MEMO

Project:	Glen Isla Coastal Protection Project	Document No.:	Mm 002 r02		
To:	Glen Isla Protection Society	Date:	6 December 2024		
Attention:	Allan Fraser	Cross Reference:	Mm 001 r01		
Delivery:	Email	Project No.:	20240399		
From:	James Whitlock	No. Pages:	8	Attachments:	Yes
CC:	Lincoln Fraser	Luke Faithfull			
Subject:	Response to s92 queries

We have reviewed the Section 92 queries from Western Bay of Plenty (WBOP) District Council (prepared by Styles Group) received by email on 14 November 2024.

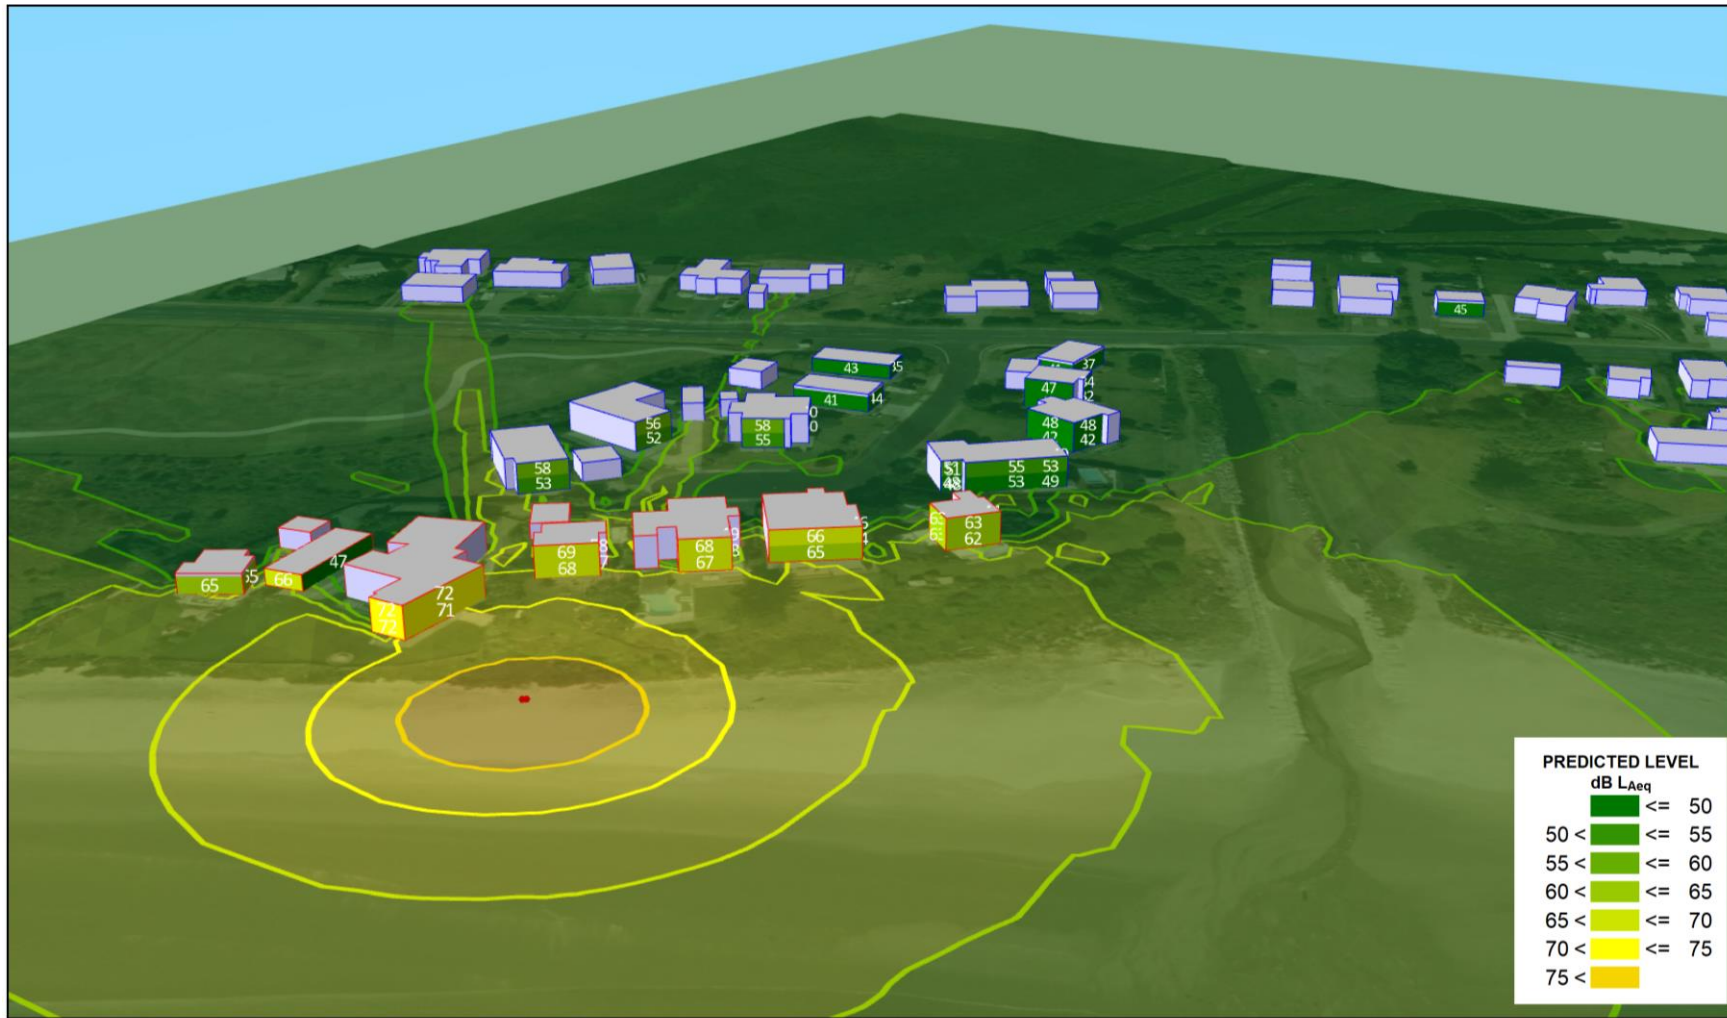
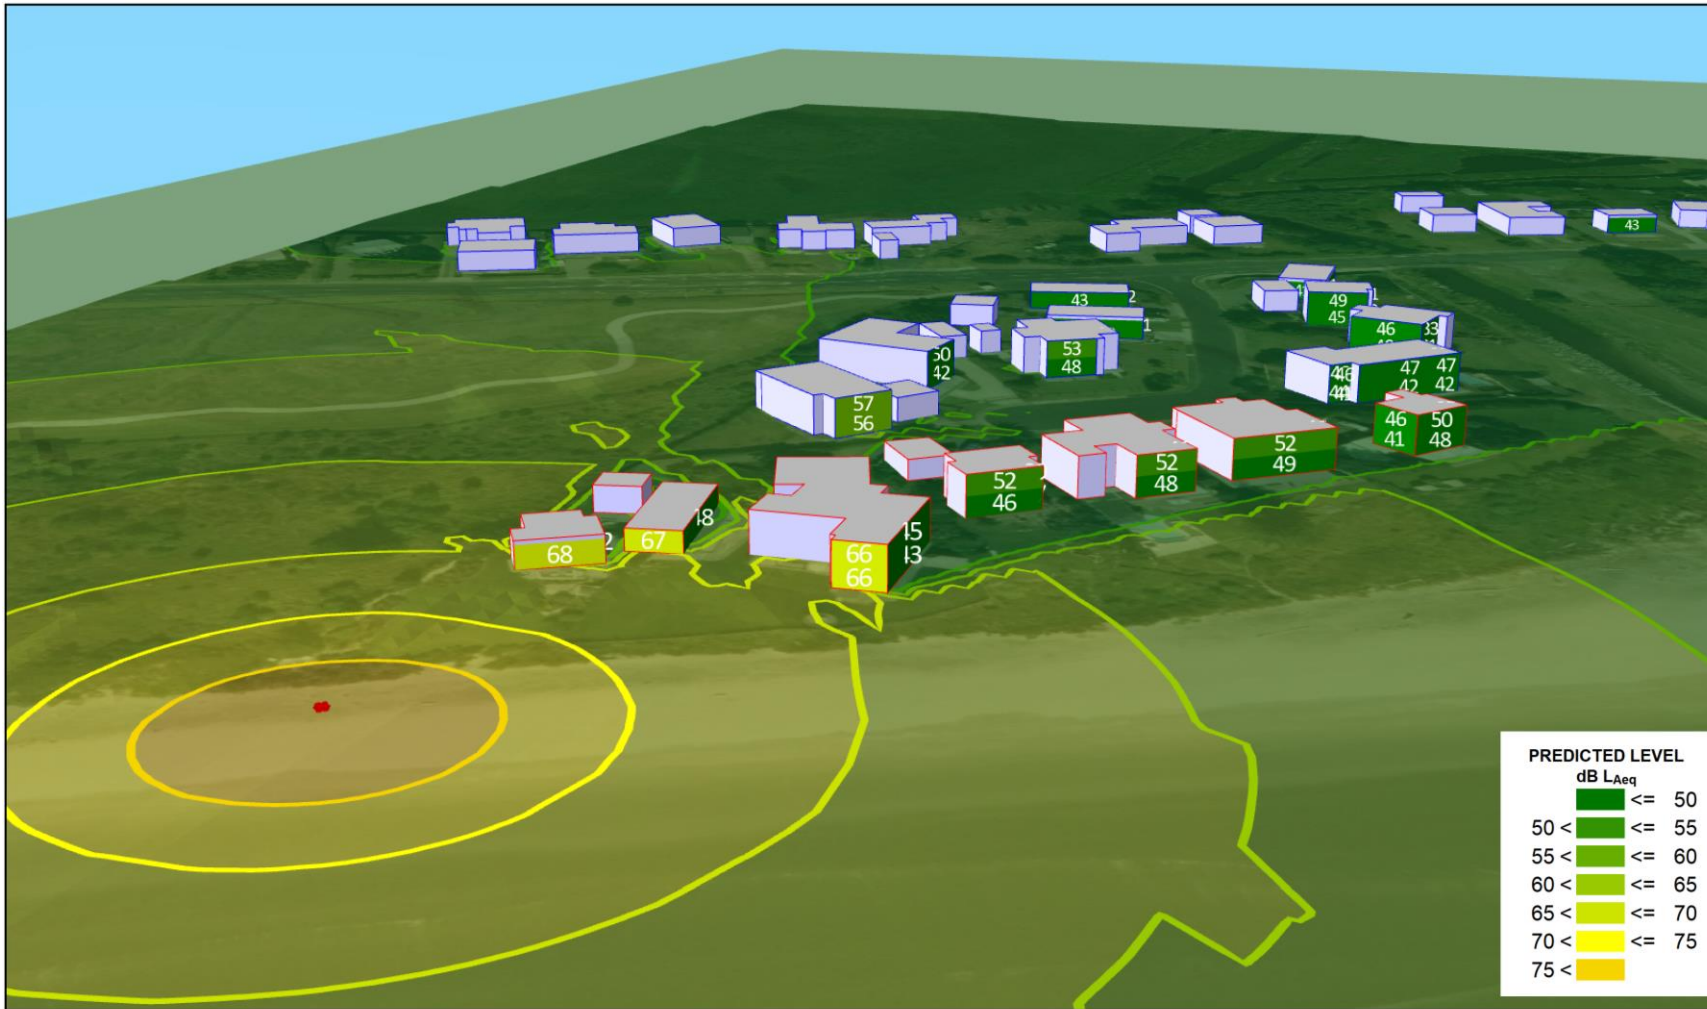
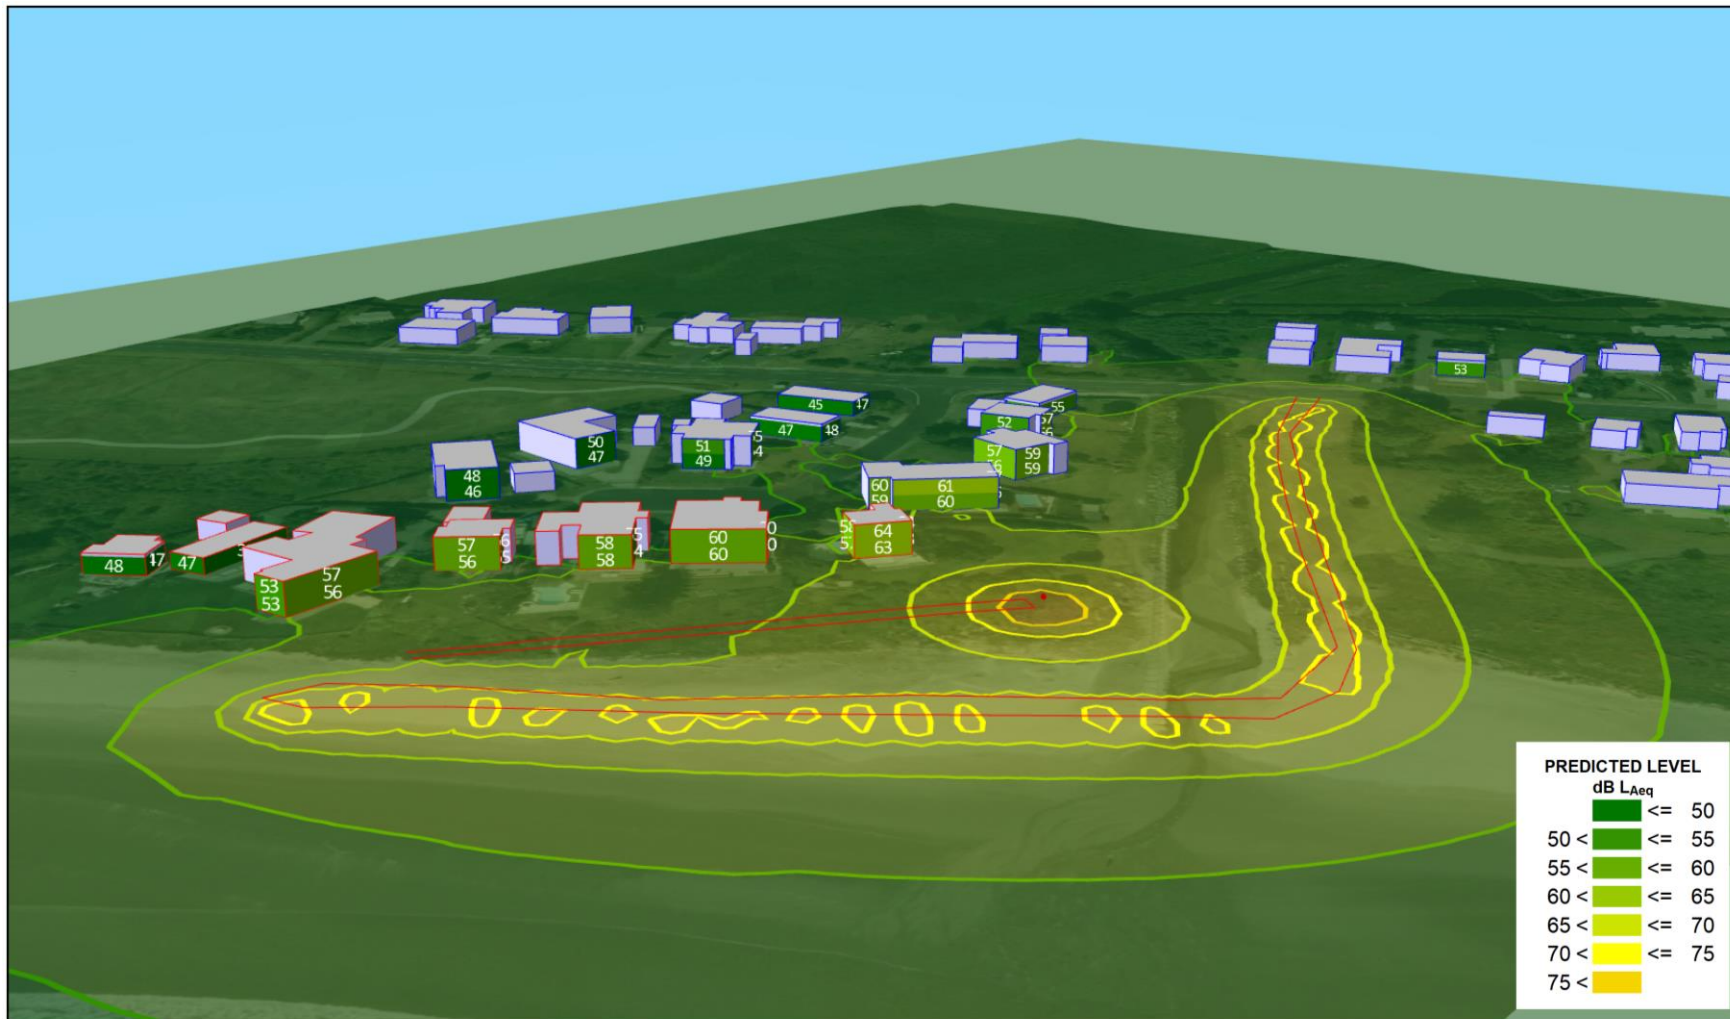
Following 1, 2, 3 and 4, I suggest MDA provide a diagram showing all properties on the northern and eastern sides of Glen Isla Place, along with 96 Seaforth Road, to label those that have given written approval to construction noise exceeding the permitted limits, and then label all other receivers with approximate noise level predictions for both the main works, and also for trucks and the excavator traversing the reserve (for the receivers close to the reserve).

Yes – the owners of all beachfront dwellings (9, 11, 12, 13, 14, 15 and 16 Glen Isla Place) are members of the Glen Isla Protection Society (GIPS), and they have all provided written approvals. This is why we didn’t assess the levels at their façades. But we have done so in response to this s92 request and included them below (GIPS members coloured grey). Note that we modelled three scenarios, as per the proposed construction plan:

- Rock drop adjacent to 15 Glen Isla Place (the northern-most drop location)
- Rock drop adjacent to 12 Glen Isla Place (the southern-most drop location)
- North end works - tractor arrival and departure, Marooka crawler and excavator works

See the figures attached to this memo. We have provided a 3D diagram for each of the three scenarios.
